Service Campaign Notification

July 02, 2026

Campaign #	Description	MBUX 3.4 Software Update – OTA
N/A	26P5497947	
☒ Over-the-Air ("OTA") Update

Figure 2 –

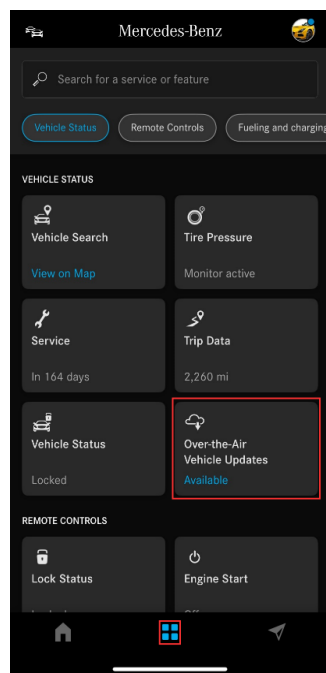
Using the Mercedes-Benz App on Android or Apple, the customer can check the status of the OTA update by going to the "Vehicle" icon and selecting "Over-the-Air Vehicle Updates" (Figure 2). A successful OTA update will show as "Installed" (Figure 3).

Figure 3 –

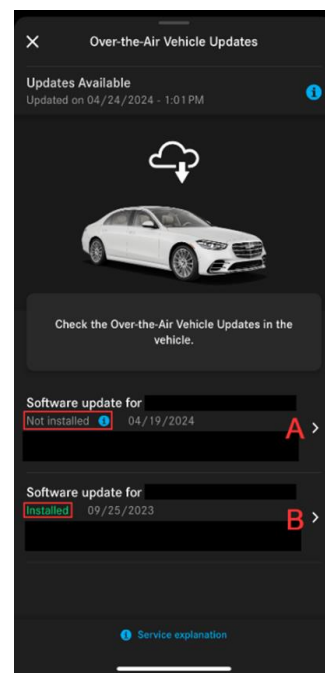
- A. Pending OTA Update
- B. Successful OTA Update
